EPC STORMWATER REVIEW COMMENTS
IN ORANGE BOXES WITH BLACK TEXT

Drainage Letter

The Landings of Denmark

PCD Proj No.: CDR-22-012

61108-O'Steen Ct Trap Channel-100yr

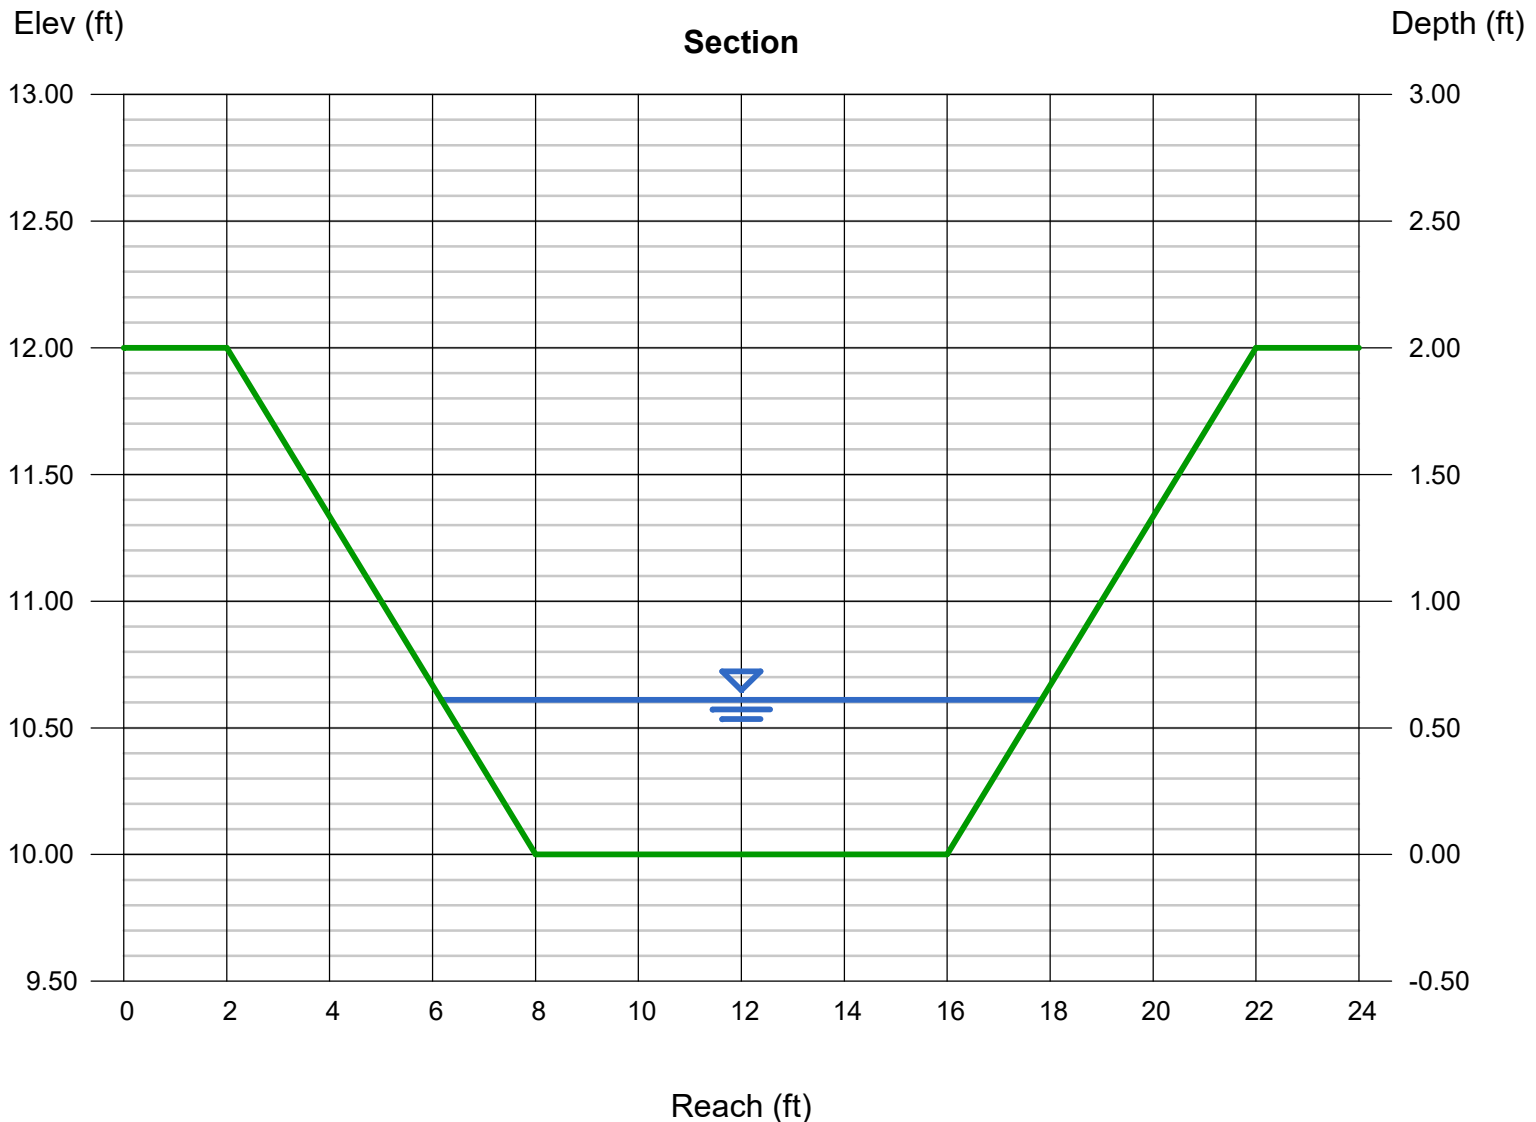
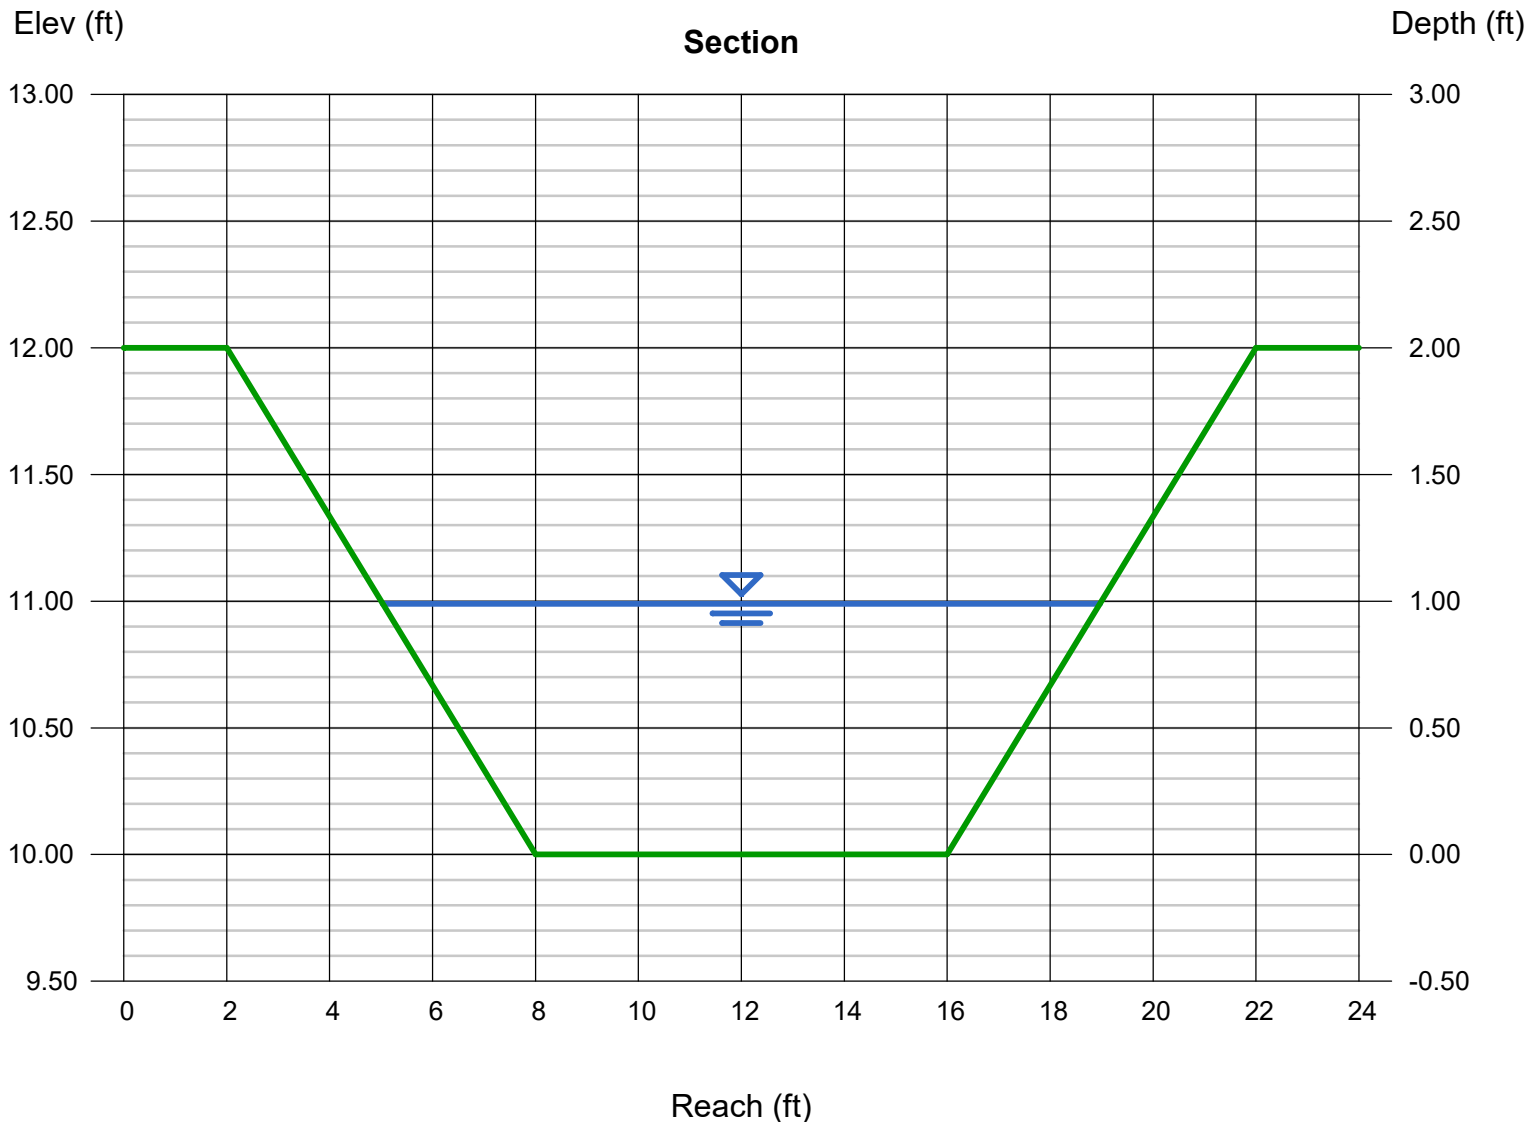
Indicate if this is for drainage channel or roadside ditch. Please provide additional calculation for whichever one this is not.

Rating Curve Plot for Crossing: Proposed Design Point 5

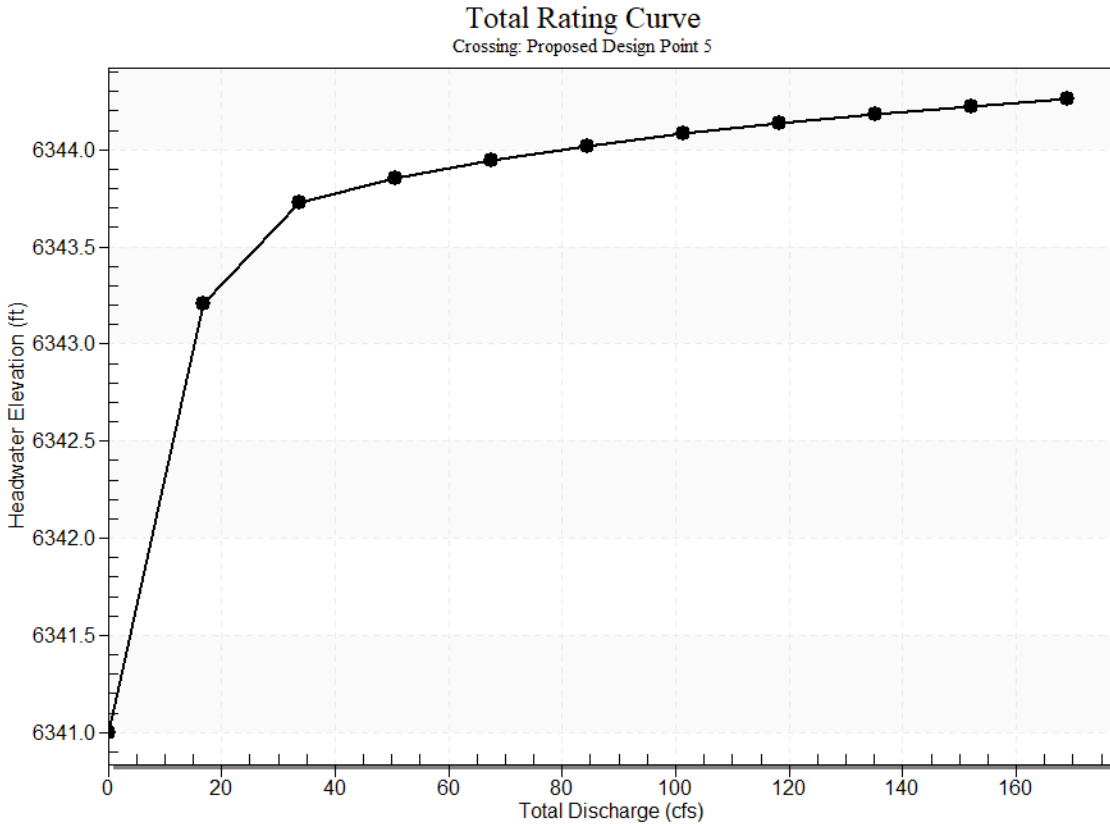
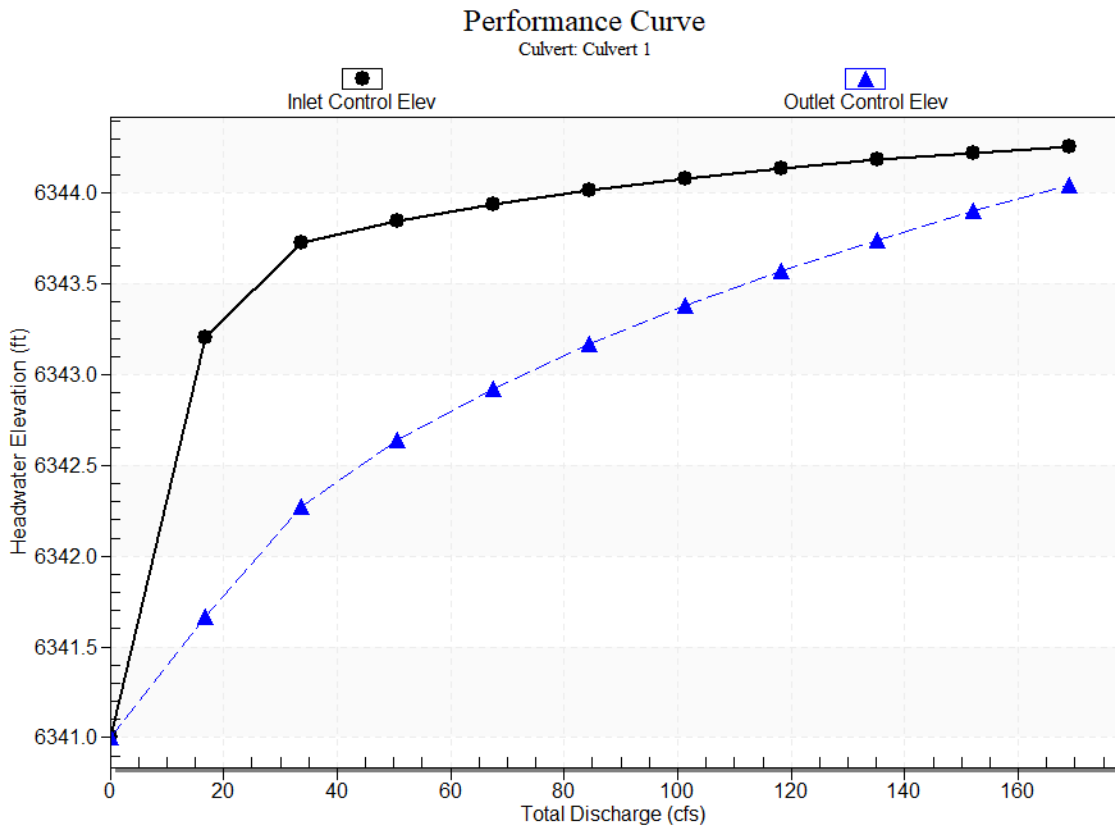
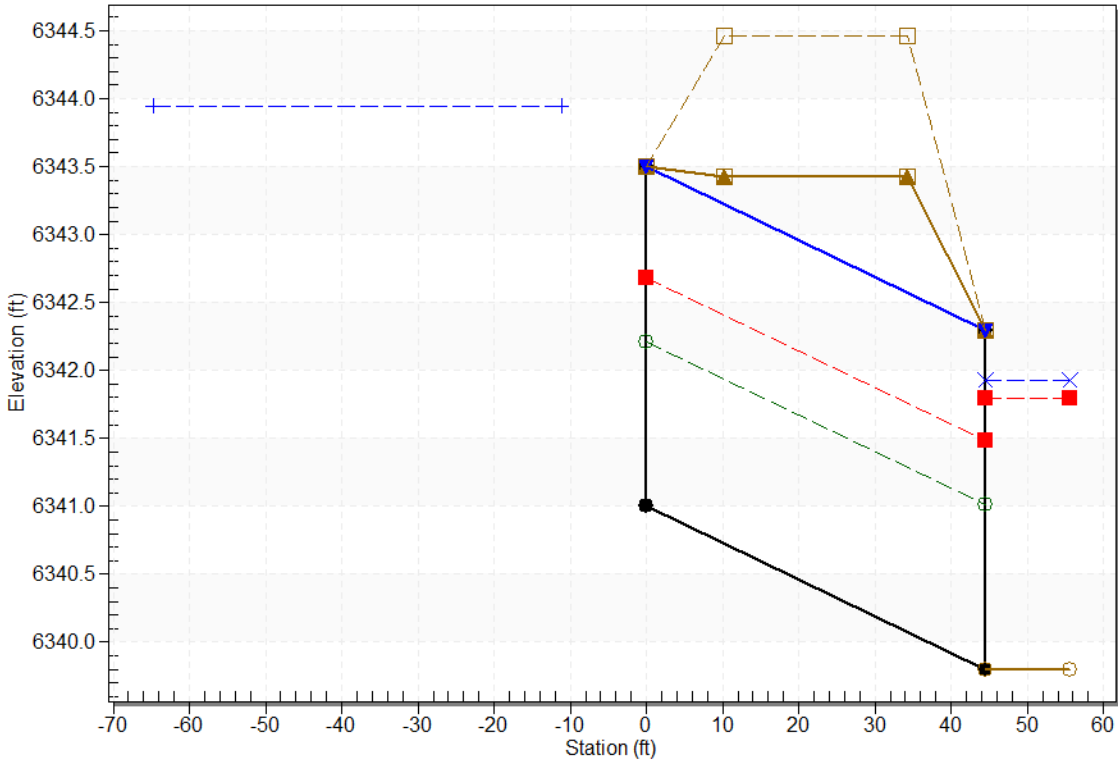
Does existing downstream channel have the depth to carry this flow? Per ECM Section 3.2.4, need to show that flows release into a "suitable outfall".

Rating Curve Plot for Crossing: Proposed Design Point 6

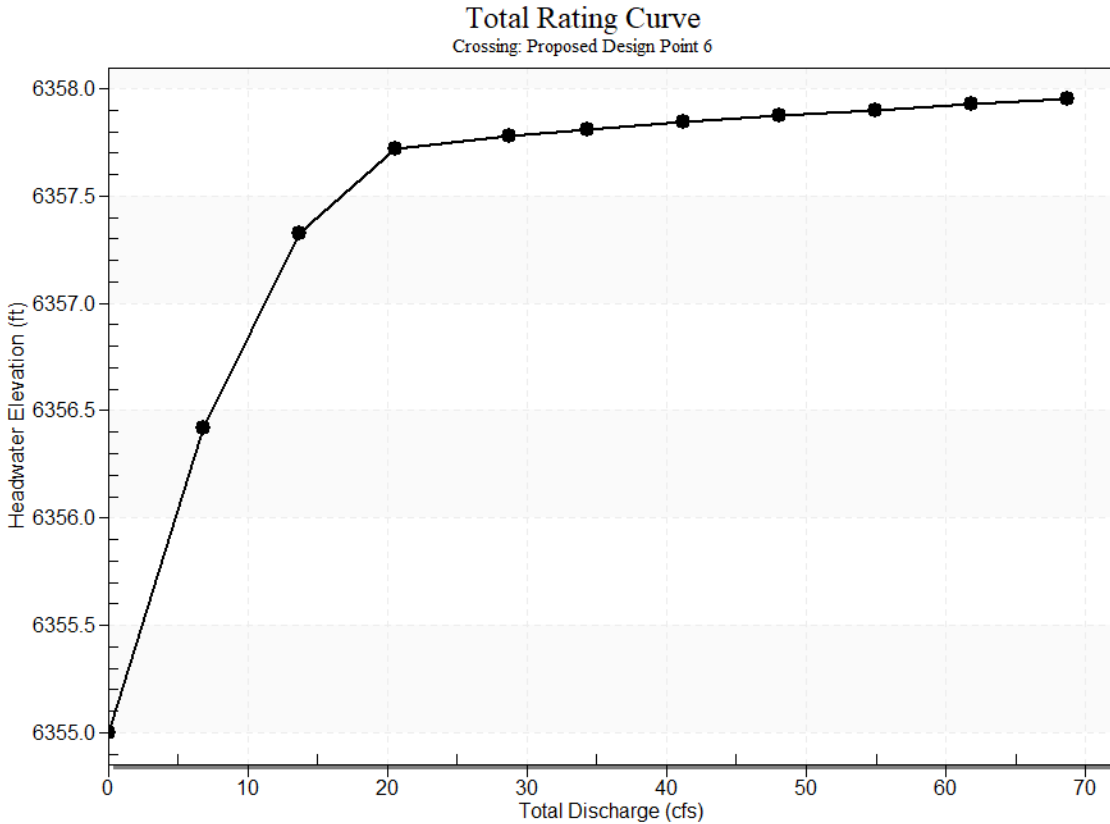
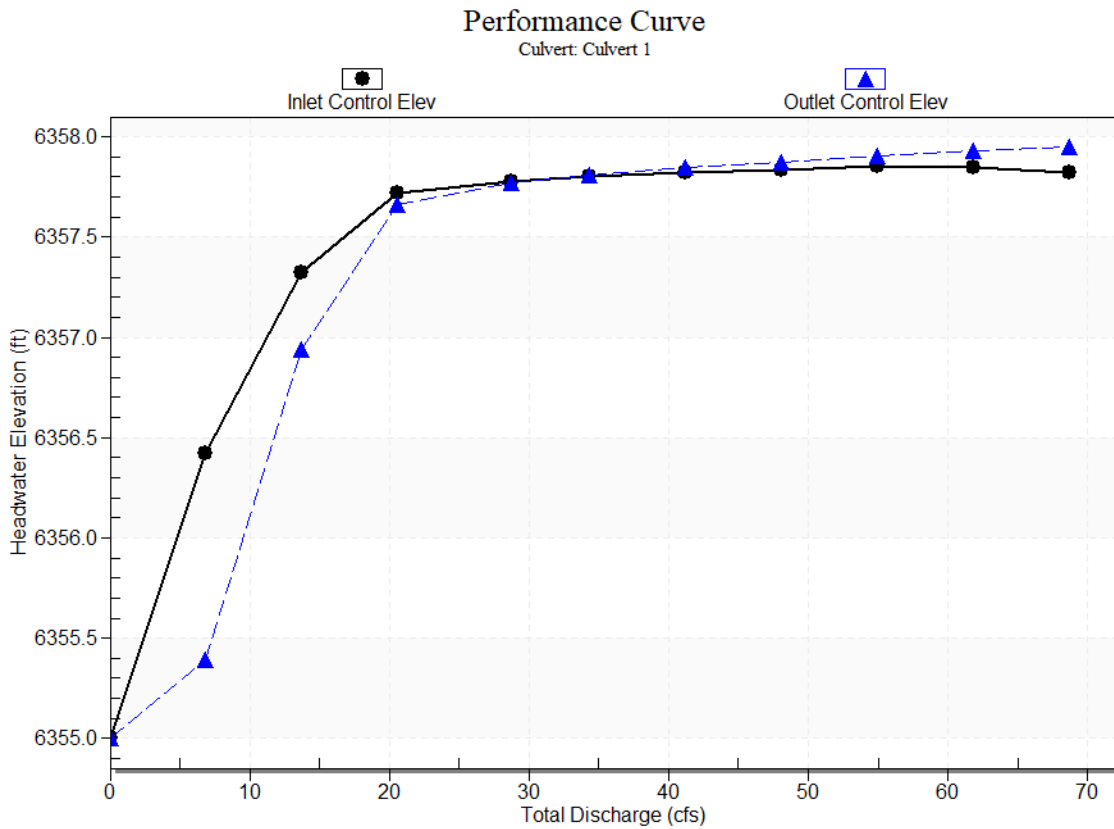
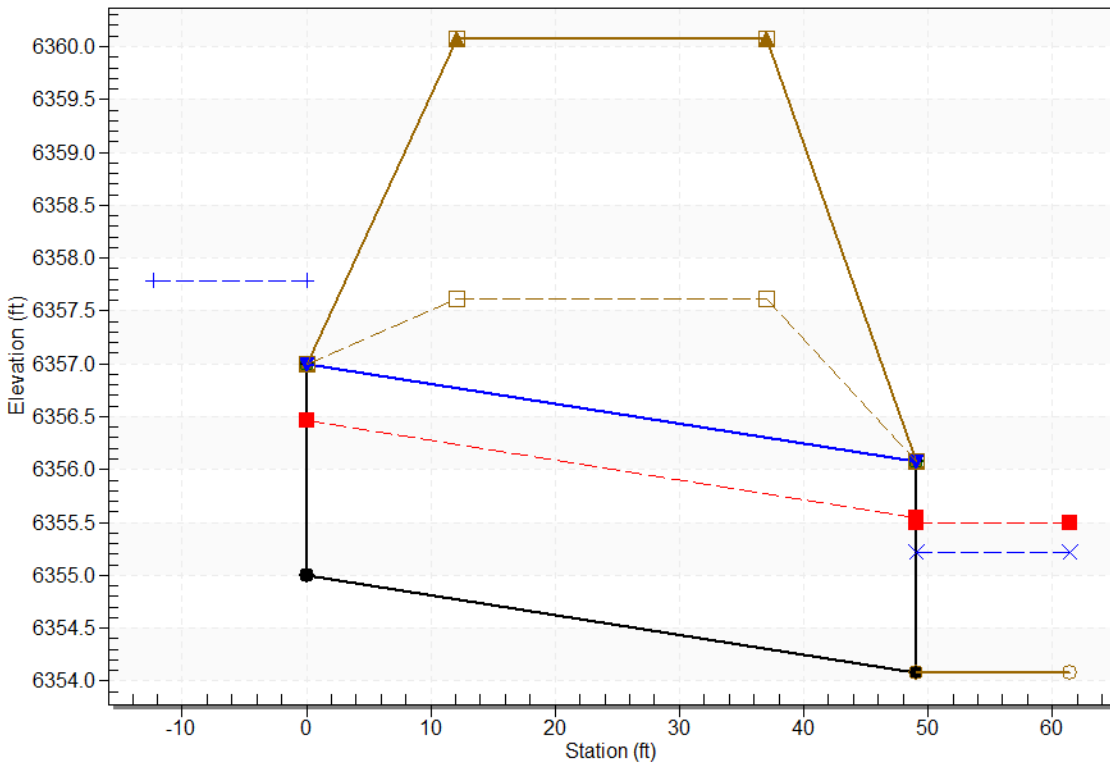
Value is high for a CSP, please refer to Figure 6C in DCM.

Does existing downstream channel have the depth to carry this flow? Per ECM Section 3.2.4, need to show that flows release into a "suitable outfall".

Design Procedure Form: Runoff R
UD-BMP (Version 3.07, March 2018)

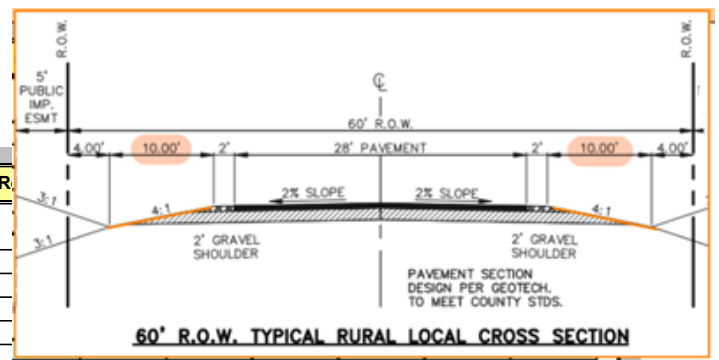
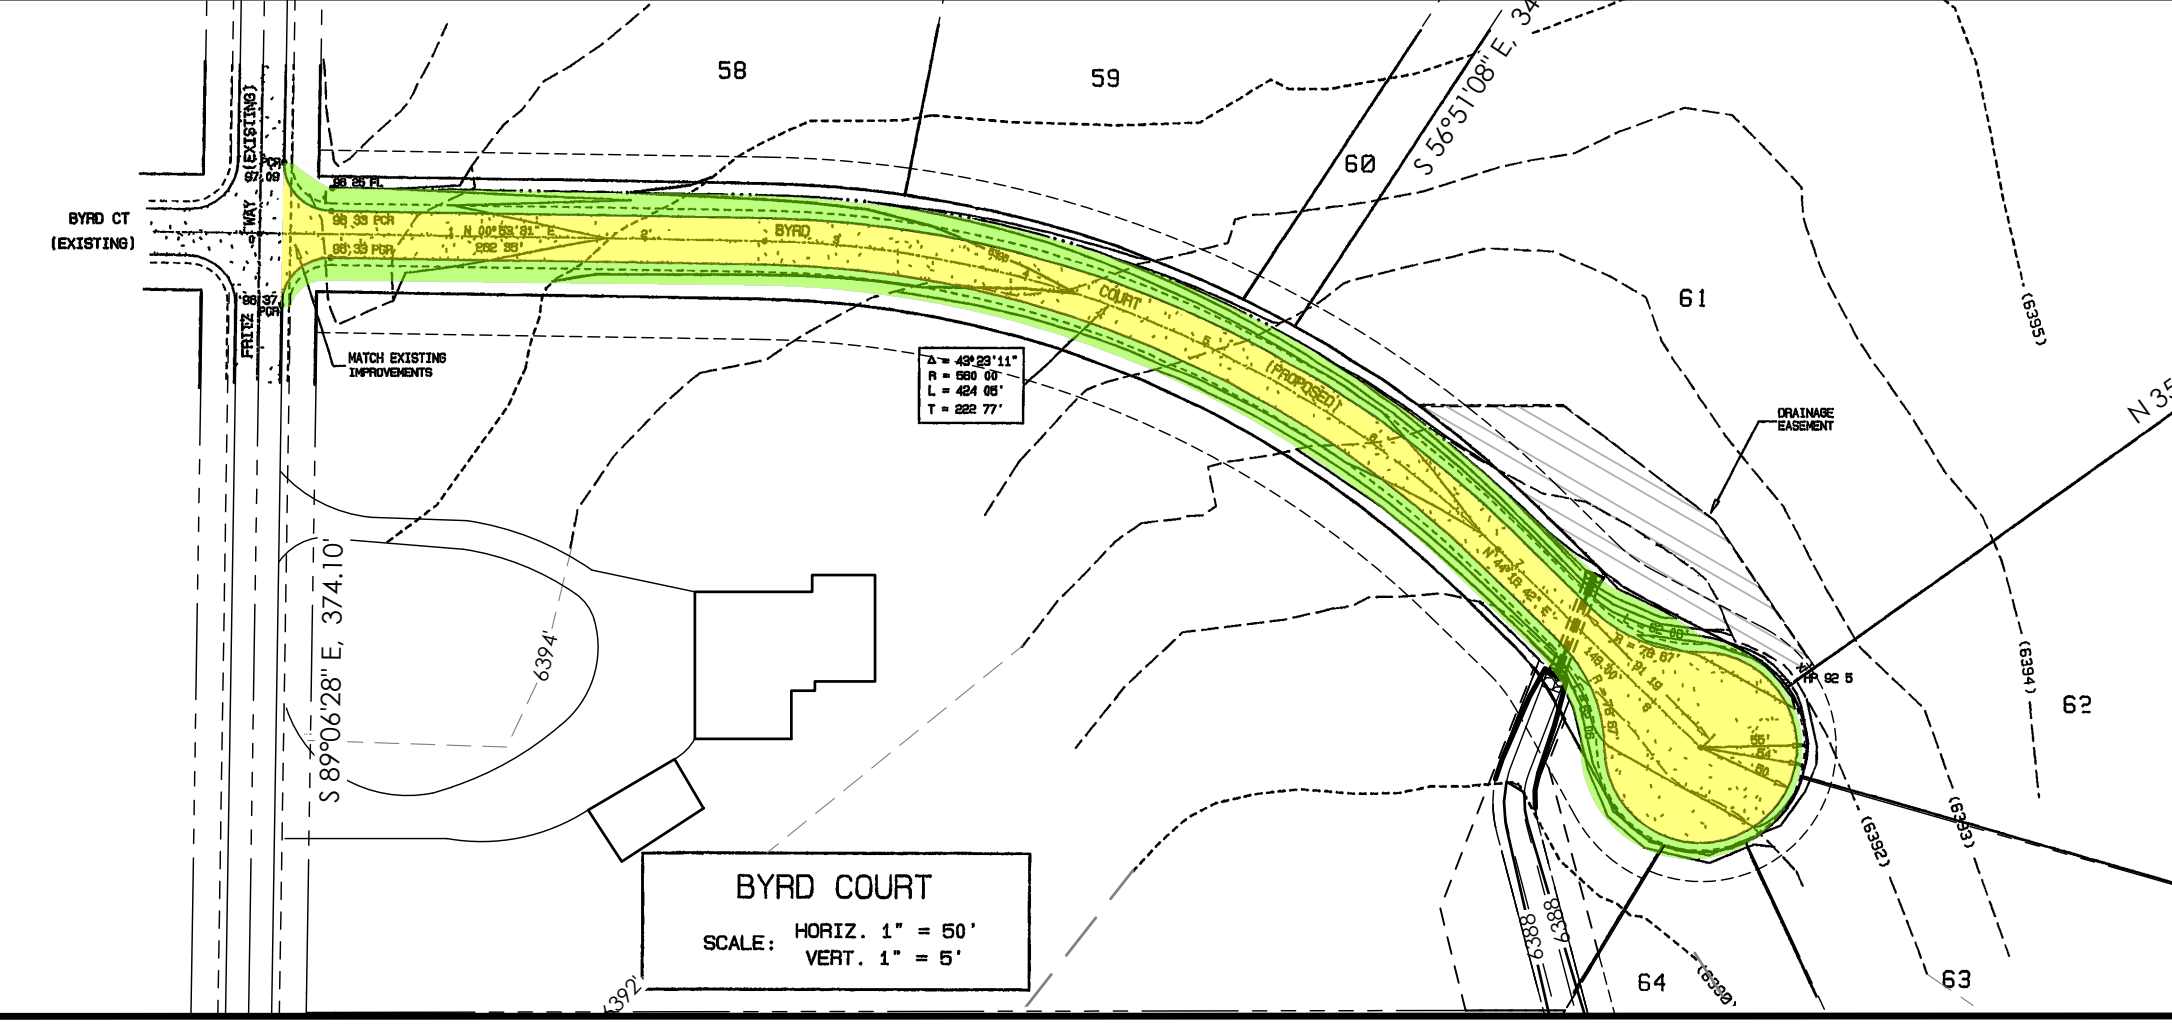
With a V ditch, you can use the portion of the ditch where the SW sheet flows off the road into the ditch for RPA (i.e. half the ditch) and the slope would be the fall from the road to the bottom of the ditch. So in the example provided the slope would be 0.25 and the RPA would be the length of the ditch times 10 feet.

interface width should be the length of the roadway where water is sheet flowing off into the ditch
